**PRELIMINARY DRAINAGE REPORT  
FOR  
SOLACE APARTMENTS**

**June 30, 2020  
Project No. 25174.00**

**PCD File No. SP201**

DRAINAGE MAP  
SOLACE APARTMENTS  
JOB NO. 25174.00  
6/26/20  
SHEET 1 OF 1

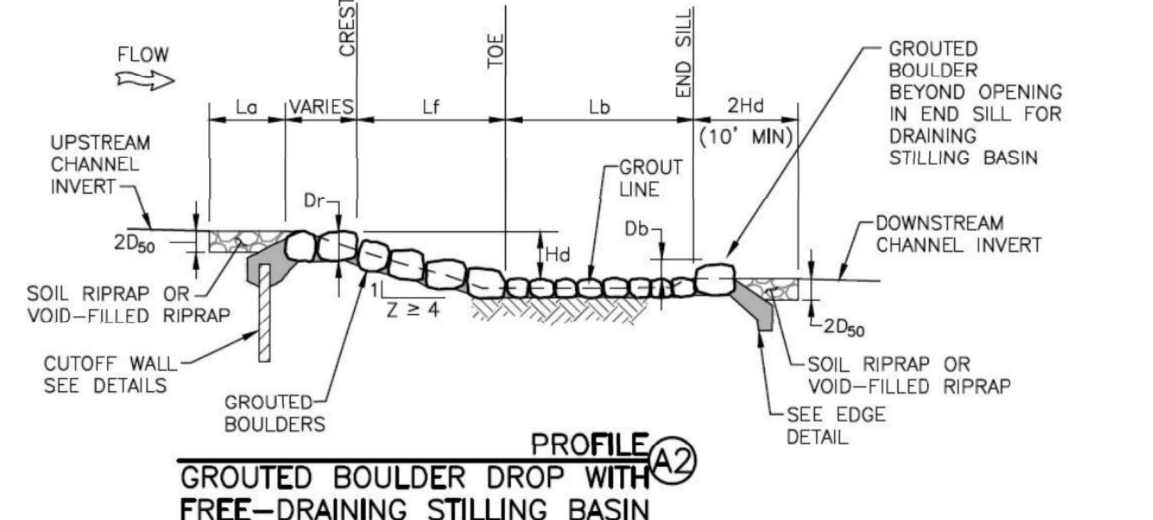
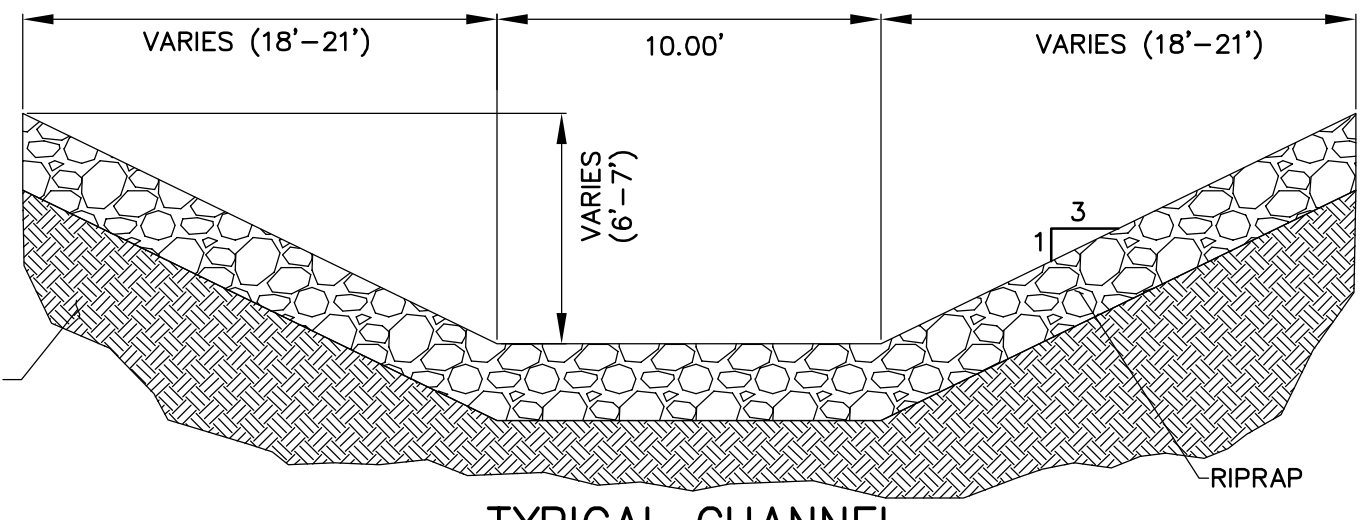
design point 6 is shown on the drainage plan. Revise accordingly.
